1968 - 1970 Corvette: Service Bulletin: Depressed Park Windshield Wipers Unable to Park

Source: Chevrolet Dealer Service Technical Service Bulletin

Bulletin No: 70-T-59

FIGURE 1

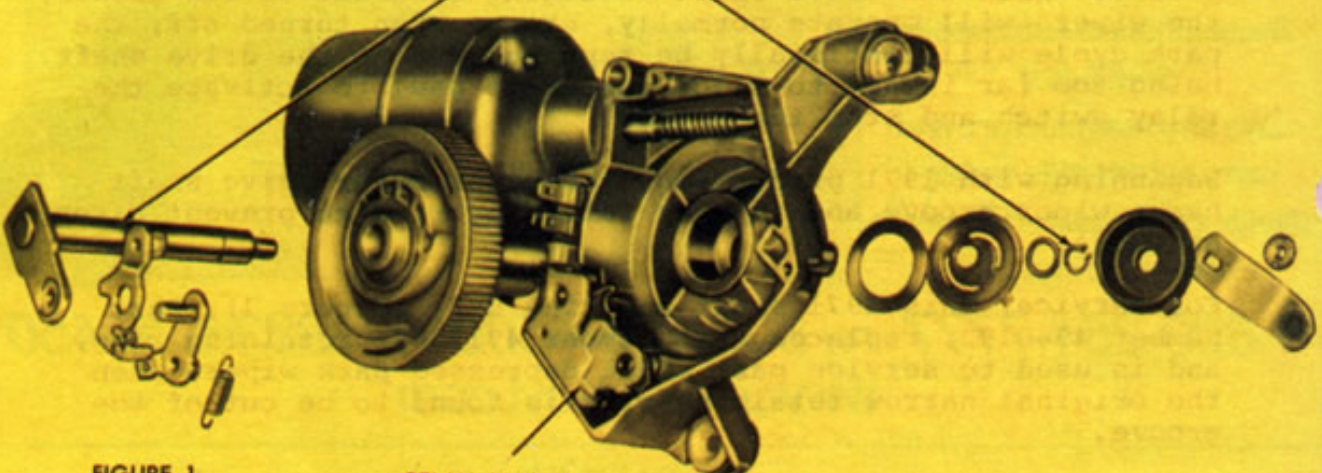
This problem usually is a result of heavy snow or ice accumulation on the lower portion of the windshield, resulting in heavy torque imposed upon the wiper arms during the park cycle. When this occurs, the wiper motor drive shaft is forced inward, and in some instances, the retaining ring may be forced out of its groove. With the drive shaft retaining ring out of its groove, the wipers will operate normally, except when turned off, the park cycle will continually be repeated due to the drive shaft being too far inward to allow the drive pawl to activate the relay switch and stop the motor.

Beginning with 1971 production, the wiper motor drive shaft has a wider groove and thicker retaining ring to prevent disengagement.

For service, this 1971 shaft and ring unit (Figure 1), Part Number 4960192, replaces Part Number 4911264, retaining ring, and is used to service past model depressed park wipers when the original narrow retaining ring is found to be out of the groove.
